## NEW & IMPROVED EMERGENCY VENT KITS FOR FUELCUBE

Western Global has improved their emergency vent kits for the FuelCube fuel tanks. These kits are for the FCP R2 (tanks with serial number 23) only.

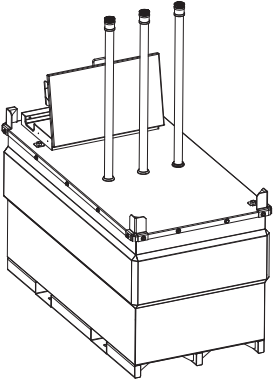
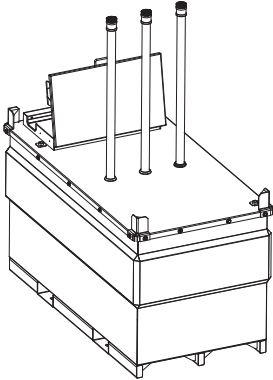
Previously, customers needed to install two, three or even four 48" vent stacks with mushroom vent cap (depending on tank size) on the ports at the top of the FuelCube. However, with the new kits, the 48" vent stacks are no longer necessary, and customers only need to install the male threaded vent in the bung at the back of the FuelCube. The only exception is in Canada, where a tank whistle must still be installed in the cabinet.

These new vent kits are for the FCP R2 only. Due to the high numbers of FuelCubes in the field, the original vent kits that do include the vent stacks remain in stock and are available to those customers that require the old R1 design.

**NOTE:** In accordance with NFPA30, an extended vent pipe will be required for the FCP1000 and 1800 when storing gasoline adjacent to a building or public way. WG would suggest to relocate tank if possible or an extension piece can be added.
